SUBJECT: COMANCHE PEAK NUCLEAR POWER PLANT, UNITS 1 AND 2 – FLOOD
HAZARD MITIGATION STRATEGIES ASSESSMENT (CAC NOS. MF7913 AND
MF7914)

STAFF ASSESSMENT BY THE OFFICE OF NUCLEAR REACTOR REGULATION
RELATED TO MITIGATION STRATEGIES FOR COMANCHE PEAK NUCLEAR POWER
PLANT, UNITS 1 AND 2, AS A RESULT OF THE REEVALUATED FLOODING HAZARD
NEAR-TERM TASK FORCE RECOMMENDATION 2.1
CAC NOS. MF7913 AND MF7914

Figure 3.2-1 Comanche Peak Site Layout Adapted from Flood Hazard Reevaluation Report

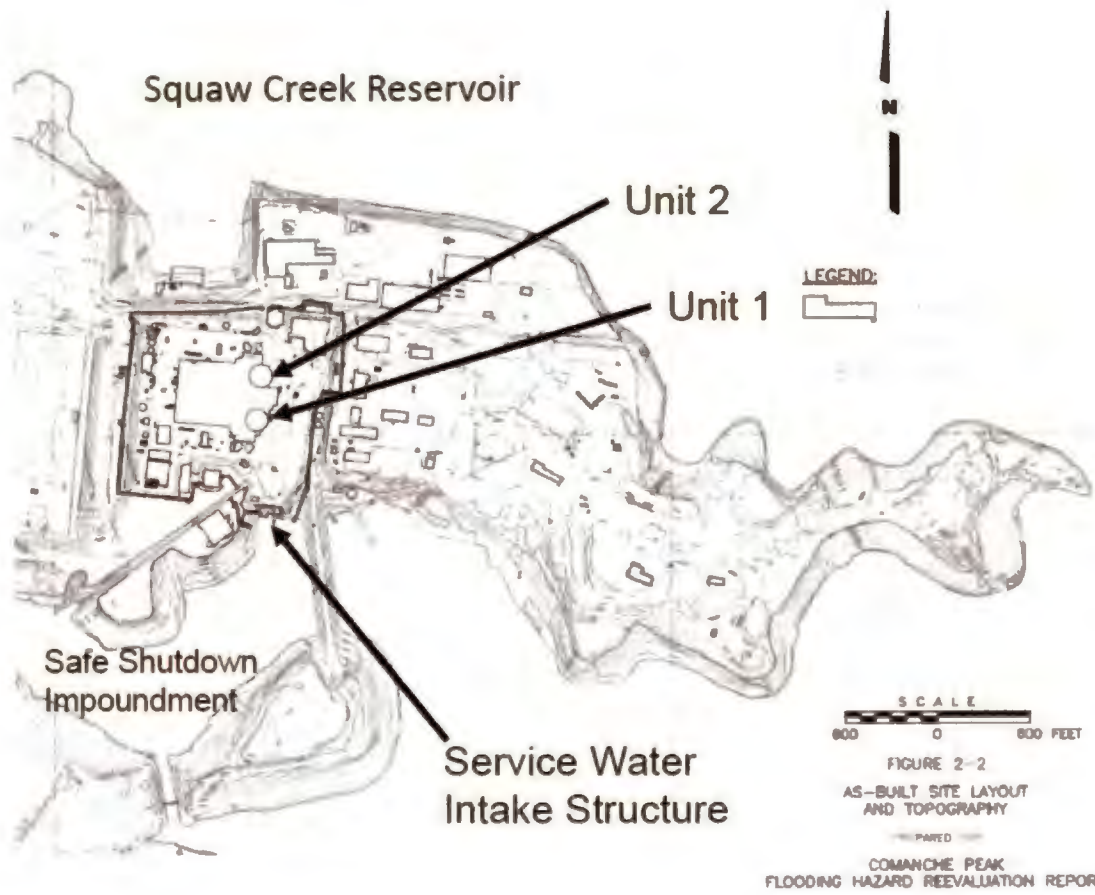
Figure 3.2-1, which is adapted from the licensee's supplement to the flood hazard reevaluation report (FHRR) dated August 14, 2014 (ADAMS Accession No. ML14245A136), provides a site layout for the plant. Section 3.3 and 3.4 of this report provides the staff's assessment of the AE parameters and FED parameters, respectively, provided by the licensee in its MSA. The AE and FED parameters were found to be acceptable by the staff and are considered in the staff's assessment of the current FLEX strategies against the reevaluated hazard LIP and streams and rivers PMF that is provided below.

As noted in the licensee's MSA, LIP was not considered in the plant design-basis or FLEX design-basis flood hazard. The MSFHI water level for the LIP event is 810.6 feet (ft.) National Geodetic Vertical Datum of 1929 (NGVD29). The licensee compared the FLEX equipment elevation to the maximum LIP flood levels and concluded that bottom portions of some electrical cabinets and panels could potentially be wetted, but it was concluded that there is no electrical equipment in the bottom portion of these cabinets. The licensee further concluded that no equipment important to FLEX or any connection points would be adversely impacted by this event. The licensee's evaluation concluded that the FLEX strategies can be performed as designed given the impact of the LIP and no additional flood protection measures or operator actions are required. The licensee's MSA included the following considerations:

- The maximum duration of inflow into any building entrance is 6.7 hours into the Turbine Building equipment ramp, which has a threshold elevation of 809.5 ft. The maximum duration of inflow at door entrances to safety related building areas, which have a threshold entrance elevation of 810.5 ft., is 0.4 hours.

- The Service Water Intake Structure (SWIS) operating deck is at elevation 796 ft.; however, according to the current design-basis internal flooding analysis for the SWIS, consequential internal flooding of the building cannot occur due to the open grating configuration at elevation 796 ft. This open grating design will route any flooding directly to the pump intake area below.

Based on the evaluation of mitigating strategies against the LIP, the NRC staff finds that the licensee has adequately assessed this hazard and the FLEX strategies, if appropriately implemented, are reasonably protected from the beyond-design-basis LIP event.
